**NEW YORK STATE DEPARTMENT OF ENVIRONMENTAL CONSERVATION**

Re: Interim Remedial Measure Work Plan for Paint Sludge Removal within Operable Unit 1  
Ramapo Paint Sludge Site, Site No. 3-44-064, Town of Ramapo, Rockland County

The New York State Department of Environmental Conservation (Department) in consultation with the New York State Department of Health (NYSDOH) is in receipt of the Interim Remedial Measure (IRM) Work Plan for Paint Sludge Removal within Operable Unit 1 (OU-1) dated August 24, 2012 prepared by ARCADIS on behalf of Ford Motor Company (Ford). The document is certified as required by 6 NYCRR Part 375 in accordance with DER-10 Section 1.5 by a certification received from ARCADIS on October 17, 2012. In accordance with 6 NYCRR Part 375-1.6(d)(3) the IRM work plan is hereby approved with the following modifications.

**Shop Drawing  
Letter Of Transmittal**

Drawing Number(s): B, S & J Figure 420.176-1

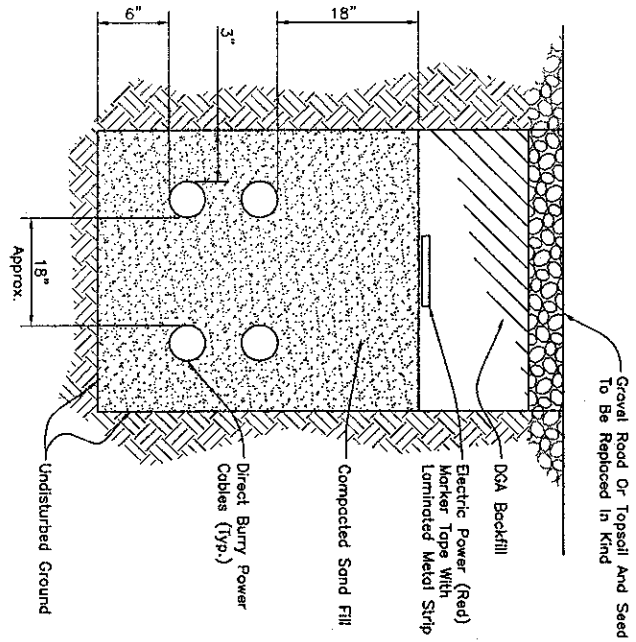
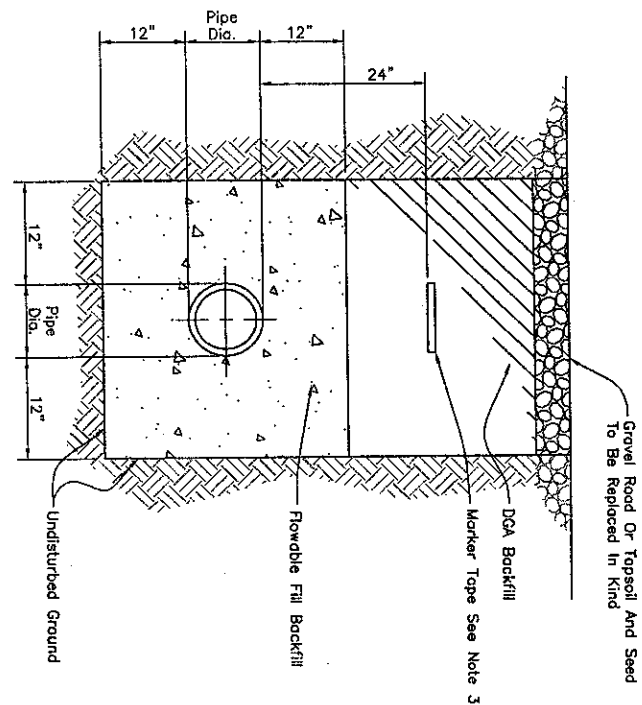
<u>Sub. No.</u>	<u>Drawing No.</u>	<u>Rev. No.</u>	<u>Manufacturer</u>	<u>Description</u>	<u>Copies Sub.</u>	<u>Copies Ret.</u>	<u>BS&amp;J Action</u>	<u>See Remarks</u>	<u>BS&amp;J Index No.</u>
1	Submittal No.10d	0	Tilcon NY West Nyack Pit	Tracking Sand Material/Certificate	1	1	NET		201

No Exceptions Taken.....	<input checked="" type="checkbox"/>
Make Corrections Noted.....	<input type="checkbox"/>
Revise and Resubmit.....	<input type="checkbox"/>
Rejected.....	<input type="checkbox"/>
For Information Only.....	<input type="checkbox"/>
